STAFF REPORT 06-26-2019 MEETING
APPLICATION NUMBER: 19-6300
ADDRESS: 2221 WABASH
HISTORIC DISTRICT: CORKTOWN
APPLICANT: TIMOTHY FLINTOFF/4545 ARCHITECTURE

PREPARED BY: G. LANDSBERG

RE: 2221 Wabash St – New Construction Historic District Commission Submission

DEMOLITION FLOOR PLAN
SCALE: 1/4"=1'-0"

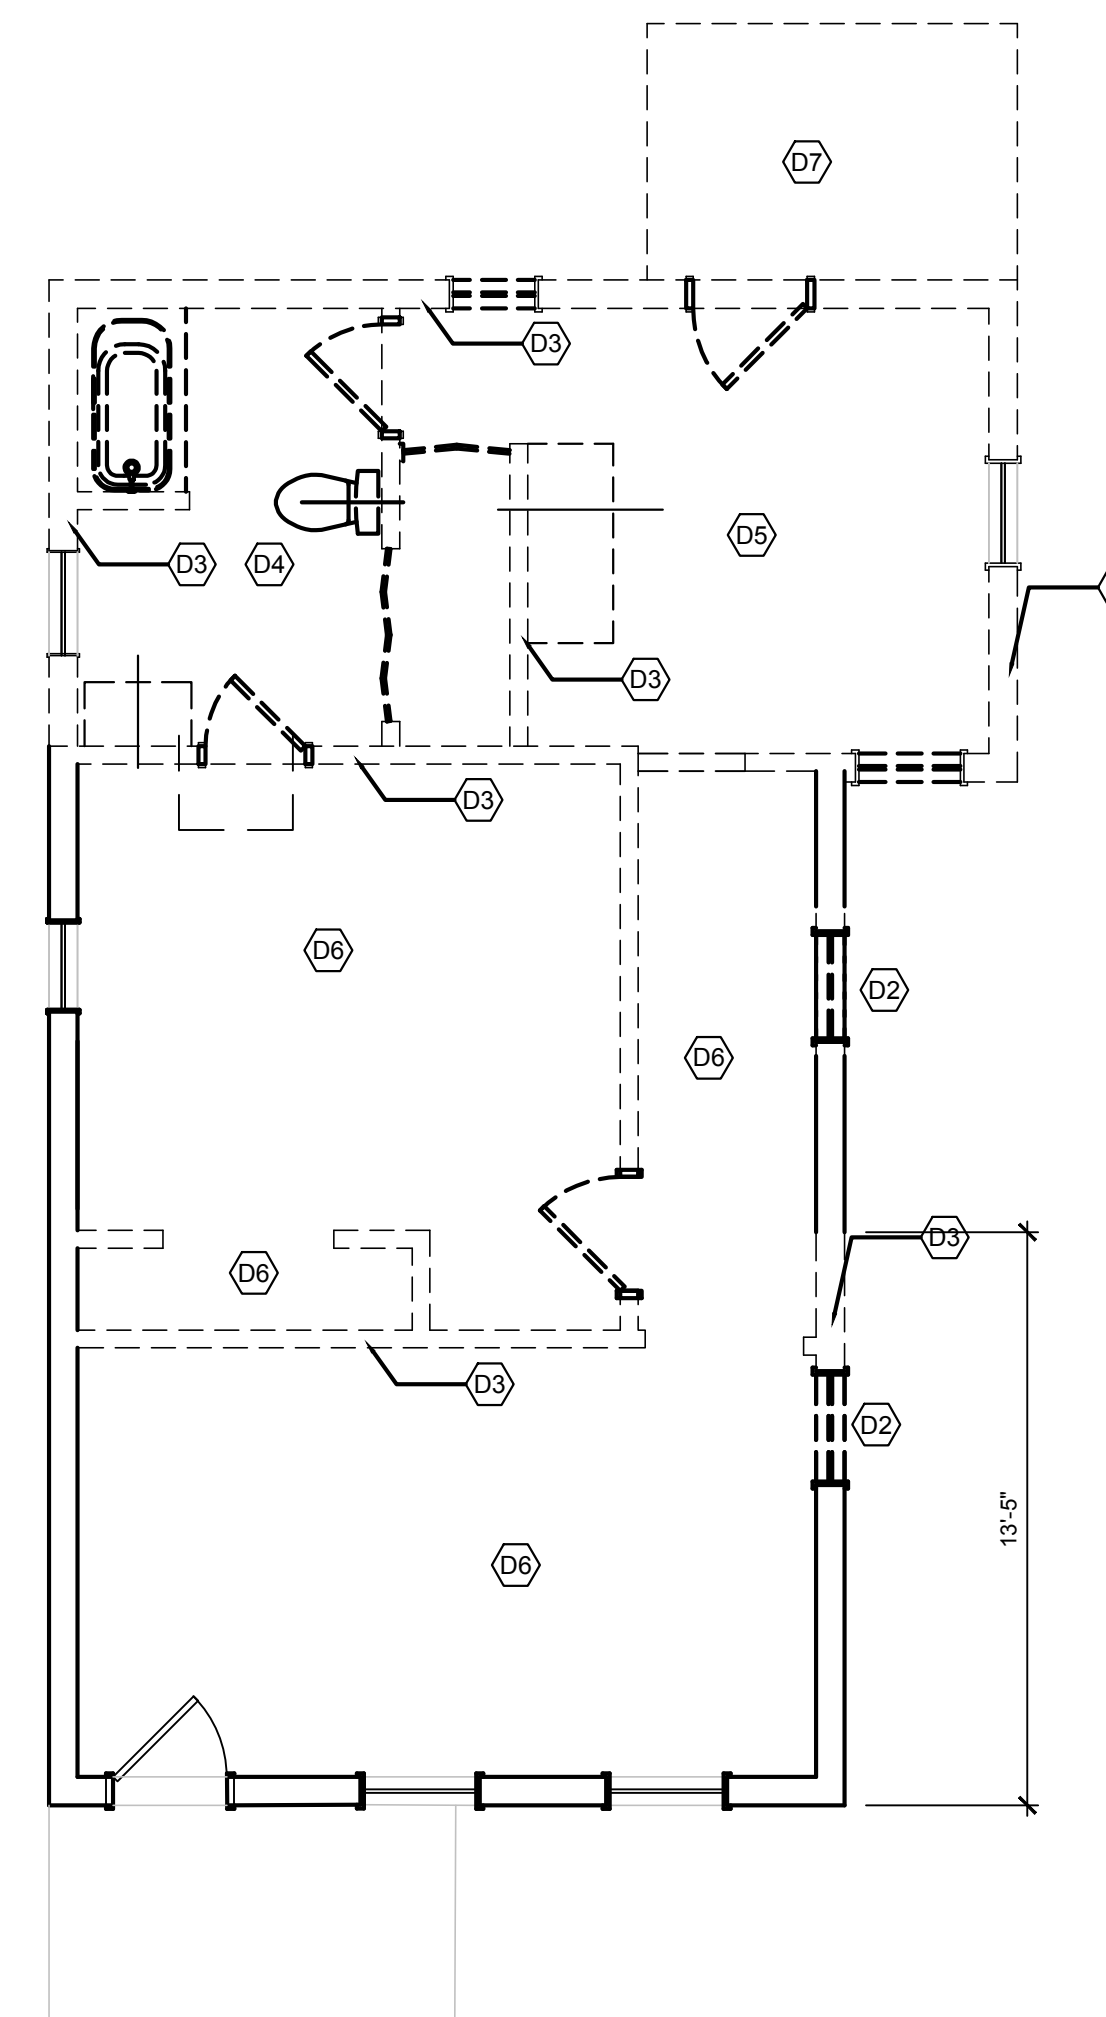
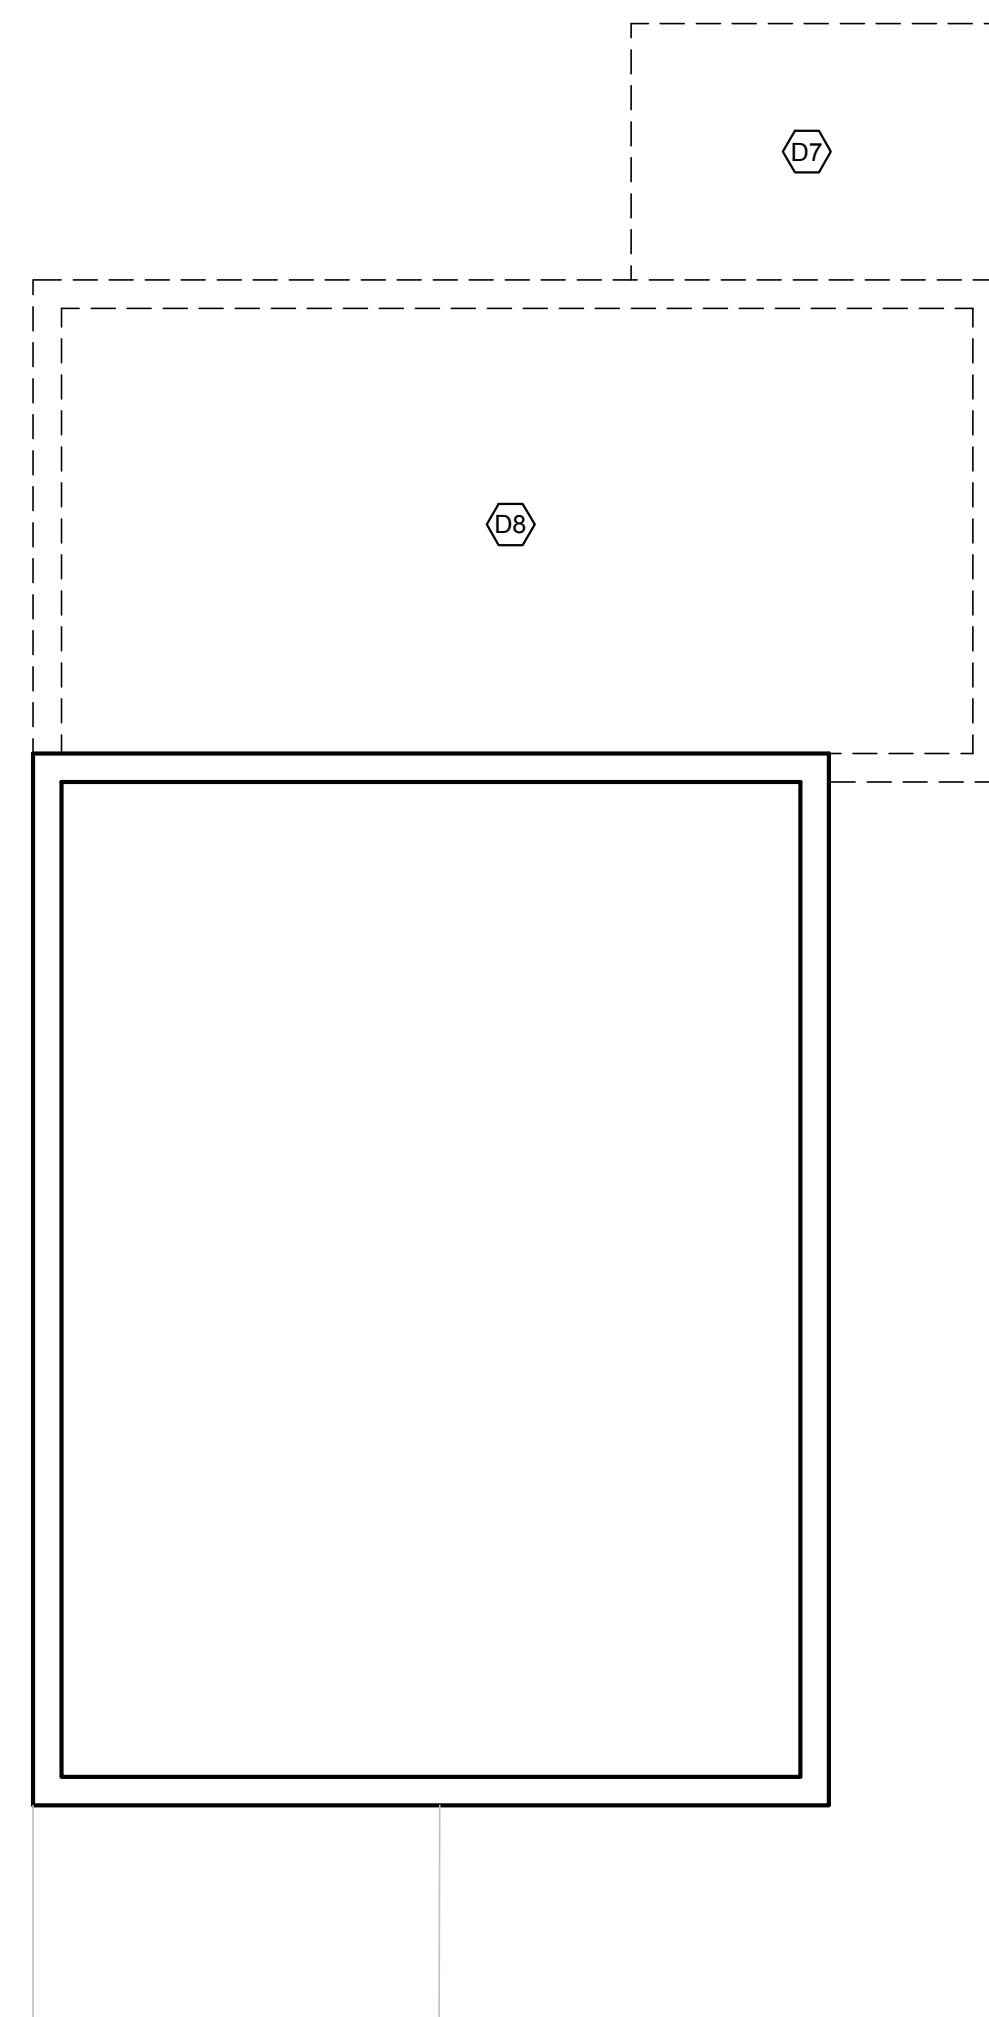
The applicant is proposing to remove the rearmost portion of 2221 Wabash, which is described in the application as a later addition. This portion incorporates the existing bathroom and kitchen, and may have been added early in the building's history to provide additional plumbed facilities to a very modest-sized dwelling. Per the above, the "addition" appears on the earliest available Sanborn map of the property, making its history difficult to discern. Given the awkward geometry, it is staff's opinion that the addition was a historic-age addition to the (slightly) earlier original structure. In many cases such historic-age additions were not well integrated into the original structural system.

The applicant does not however seek to demolish the entire structure, but instead remove the “addition,” make various interior configuration changes, structural improvements and alterations, and erect two modern additions to the rear and north side of the building. The proposed additions will expand the building’s footprint from approximately 450 SF to 650 SF. The newly proposed north addition features a dramatic raking roofline which takes cues from the original roof while preserving its original reading, overtopping it and extending the building mass to the north.

1 EAST ELEVATION
A1.1 SCALE: 1/4" = 1'-0"

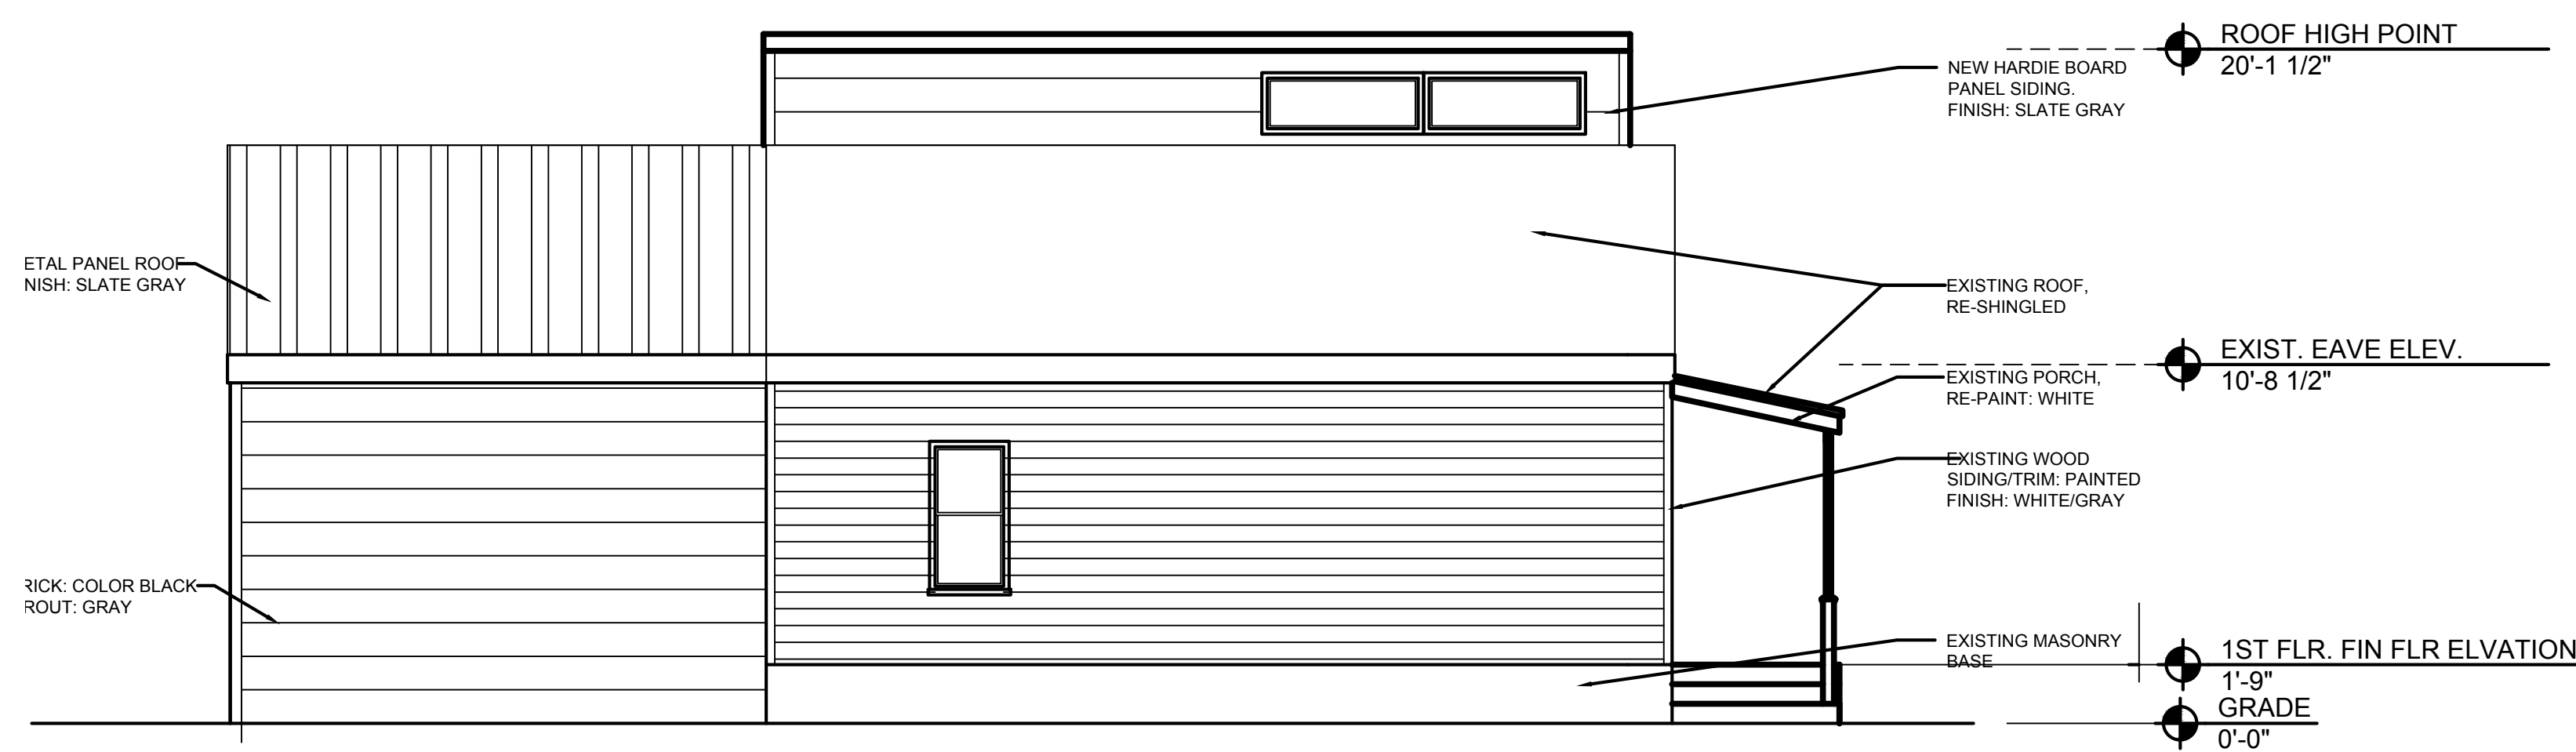
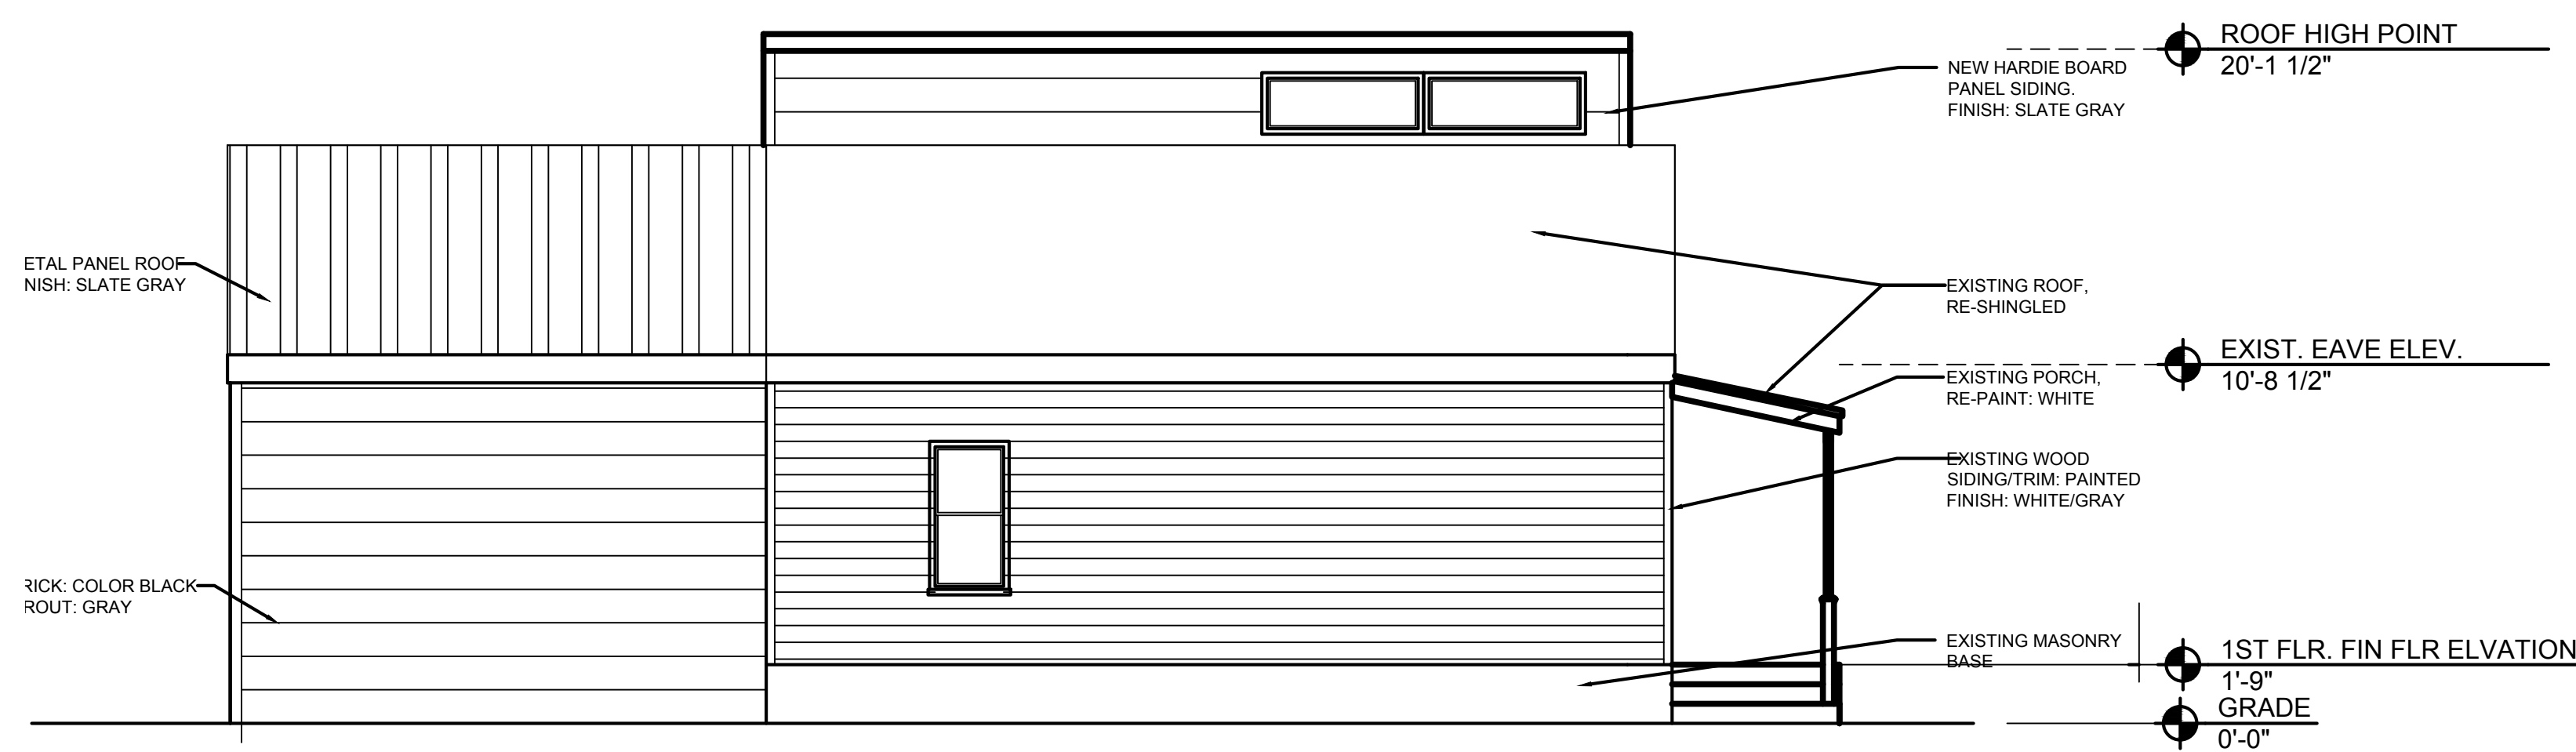
The front (east-facing) elevation of the new north addition is proposed to be brick punctuated with two 4/4 wood windows. The brick materiality of the addition is somewhat at odds with the more typical frame construction predominant for single-family homes in the district and specifically called out in the Elements of Design, as well as inconsistent with the typical relationship between historic dwellings and additions in Detroit (i.e., brick is rarely used in additions to frame houses, with the notable exception of commercial storefront additions built towards the street in front of older frame houses in the pre-war era). Typical residential additions were finished in siding, panels, or stucco. The brick is proposed to be gray or black, which, along with the small setback in plane, will recede in deference to the historic core. Note that there are several multi-family brick buildings in the district, including nearby on Wabash.

The proposed addition adds reasonable space to the area of a very small house while clearly delineating the historic core and preserving historic materials that characterize the property. Remaining original features and finishes, including the nineteenth-century clapboard siding and trim, are proposed to be preserved and repaired. While the proposed north side addition, especially, is very contemporary, the sloped roof, projecting eaves, and other gestures are generally in keeping with the district context and elements of design, and are deferential while remaining distinct, serving almost as a visual bracket. Staff therefore recommends that the Commission approve the proposed demolition, additions, and exterior alterations, as the proposed changes appear to be appropriate per Secretary of the Interior Standards 5, 9, and 10; however, staff does recommend a condition that the use of brick on the addition be reduced to the foundation only.

I move that the Commission issue a Certificate of Appropriateness for the work proposed in application #19-6300 because the work as proposed meets the Secretary of the Interior's Standards for Rehabilitation Numbers 5, 9, and 10, contingent upon the applicant working with staff to identify a material other than masonry for the addition above the level of the foundation wall.
